ADDENDUM NO. 3

RE: Architect's Project #: 2301 A1

Project: **Bandera County Visitor Center
Phase 2 – Historic Stabilization**

SHEET NO:
D-100

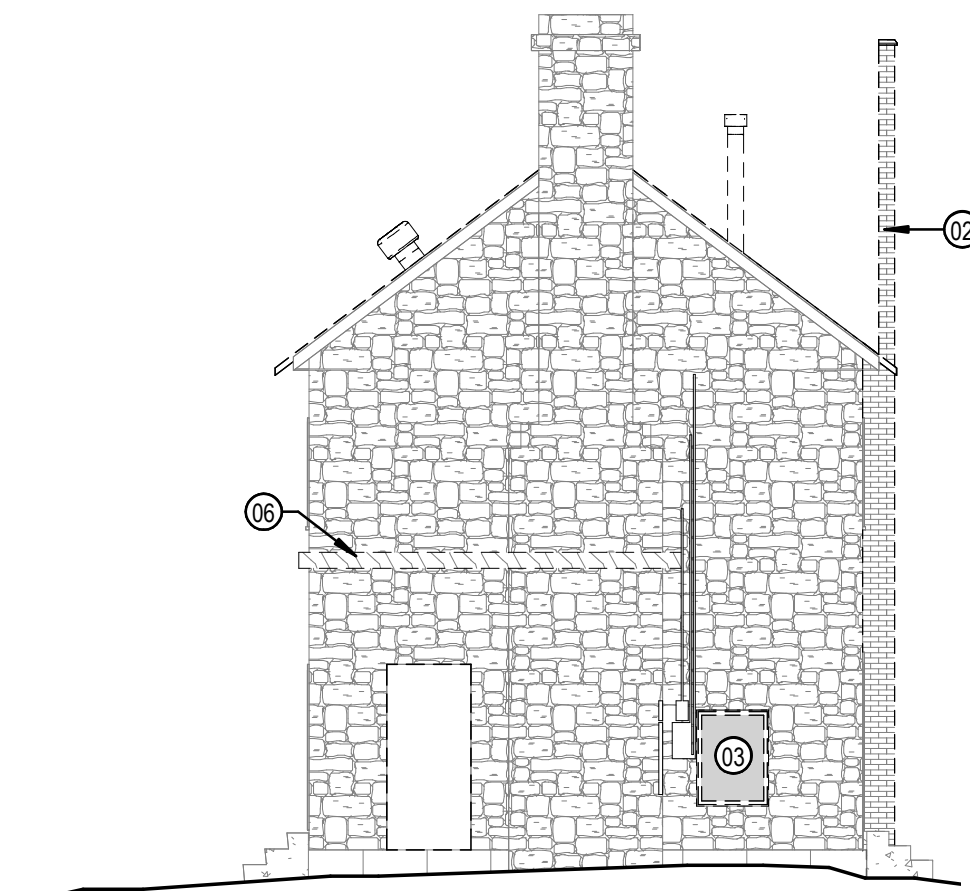
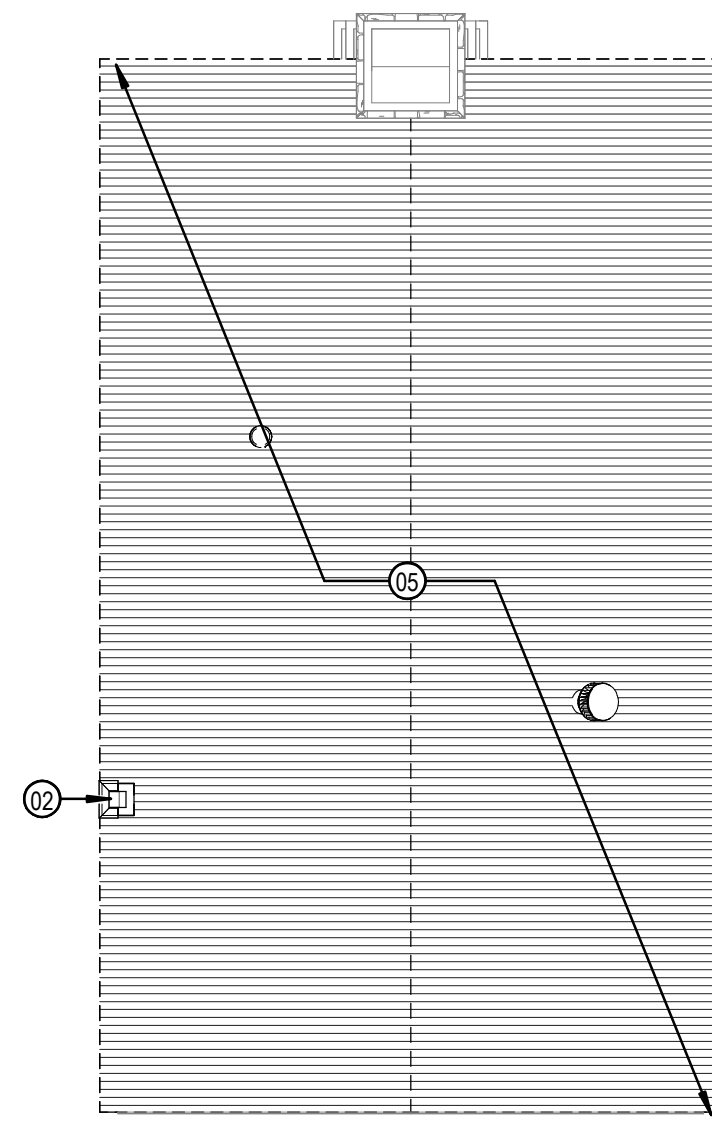
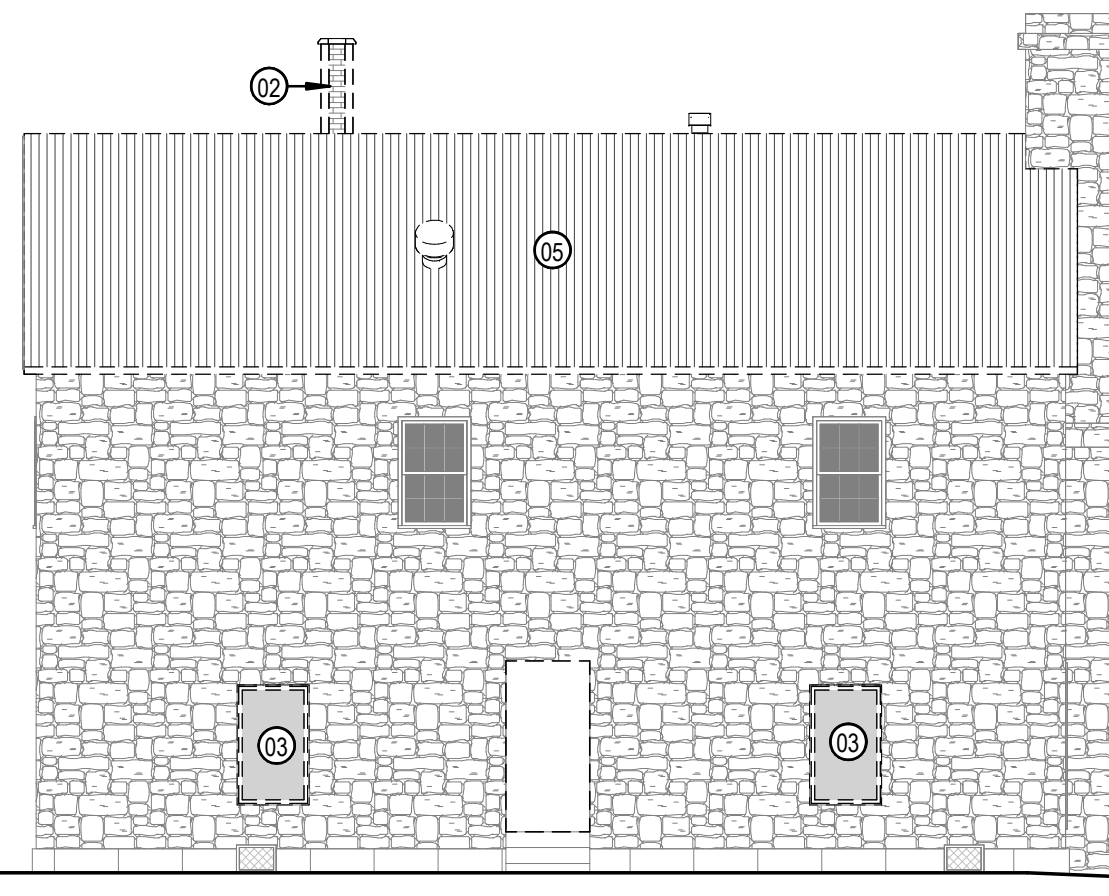
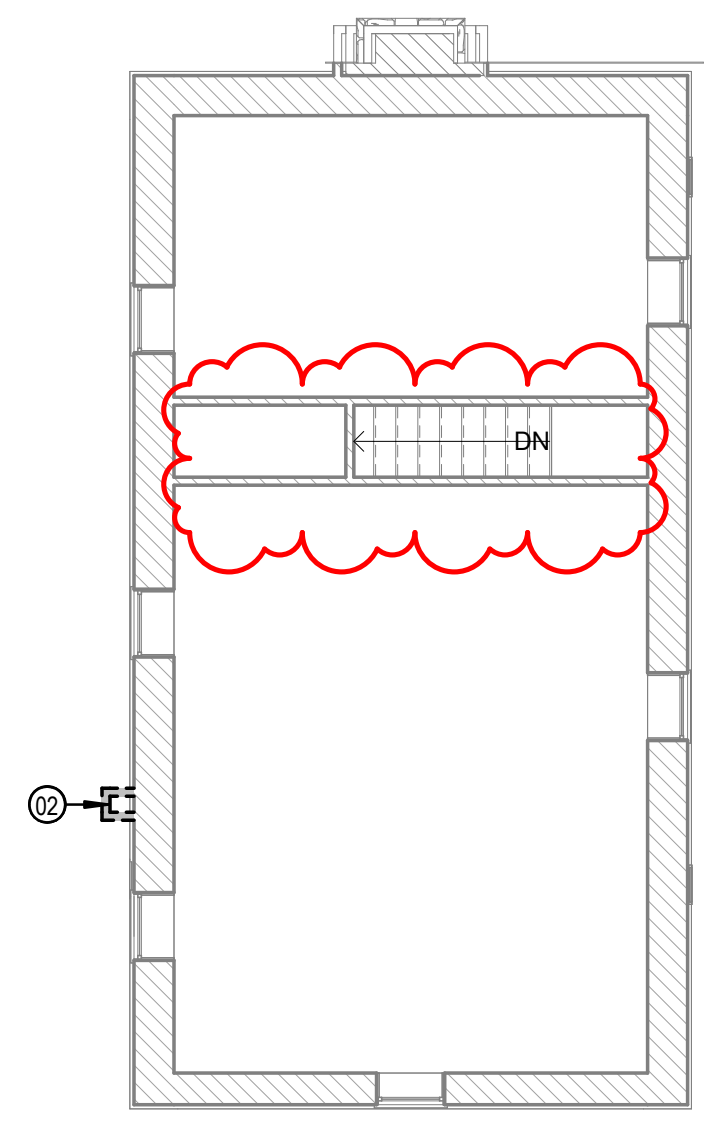
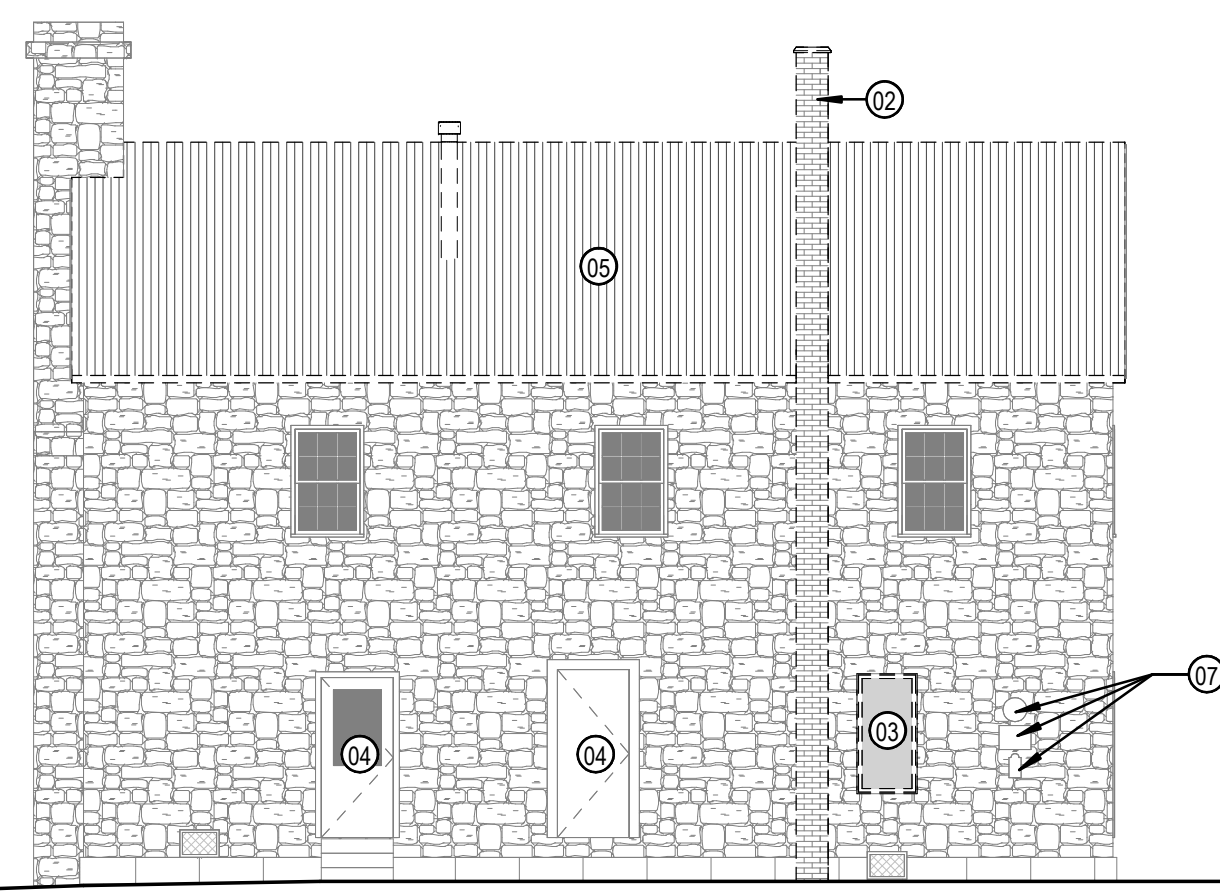
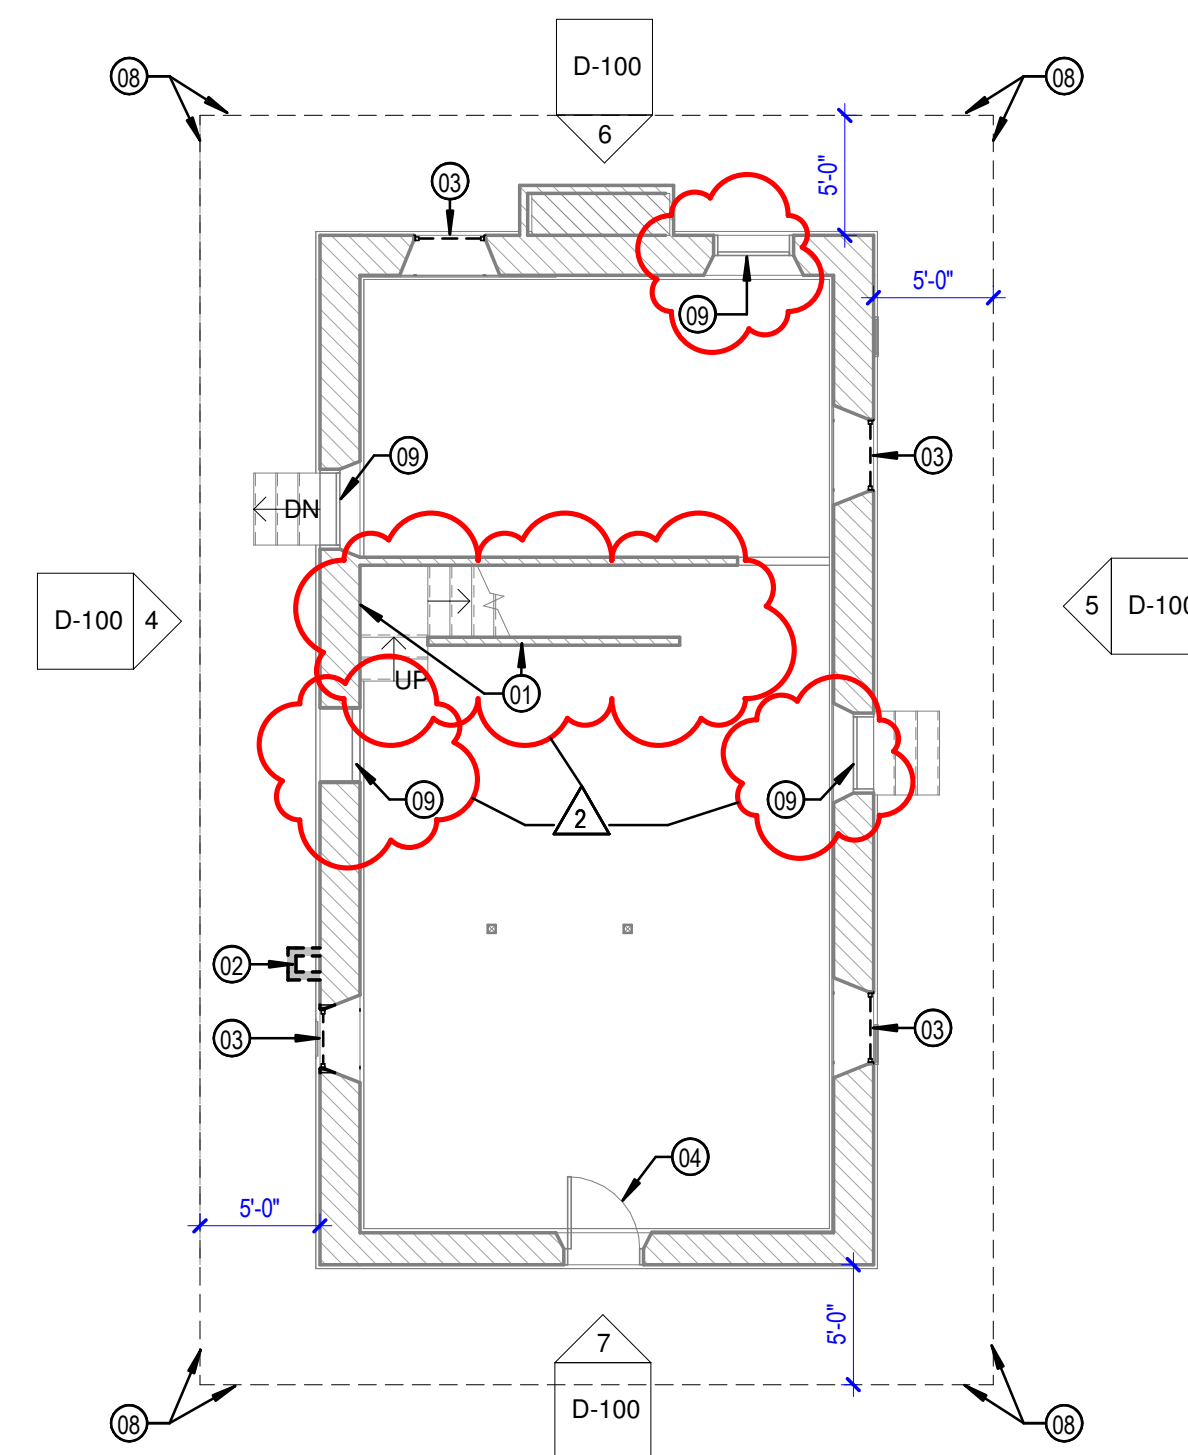
1. **RFIs** - Answers to remaining RFI questions.
2. **Sheet D100** – The following changes have been made to the sheet:
 - a. Stud walls around the stairs to remain with only any remaining wood paneling to be removed.
 - b. Remove hardware on select doors and prep them to be protected.
3. **Sheet A100** – The following changes have been made to the sheet:
 - a. Existing stud walls shown to remain.
 - b. Removed note for dehumidifier.
 - c. Keynote 09 has been modified to call for installation of horizontal 2x at 42" at stair.
 - d. Keynote 12 has been modified to call for satin paint.
 - e. Keynote 13 has been added to clarify foundation work on east wall.
 - f. Keynote 14 has been added to leave earth against east wall undisturbed.
4. **Sheet A101** – The following changes have been made to the sheet:
 - a. Added Wood Framing Notes
 - b. Added Nailing Schedule

13. D-100 Keynote 01 Is there a spec for a temporary railing where stud wall is being removed?
Leave all vertical wall framing at first and second level stair in place and add horizontal rail at 42" around for protection. Refer to sheet D-100 for this change in the drawings.

- 01 REMOVE WOOD PANELING. STUD WALLS TO REMAIN IN PLACE.
- 02 CAREFULLY DEMOLISH NON-ORIGINAL BRICK MASONRY CHIMNEY WITHIN WALL THAT RESULTS FROM THE REMOVAL OF THE CHIMNEY. SHALL BE FILLED WITH MATCHING STONE WITH A LIME-BASED MORTAR.
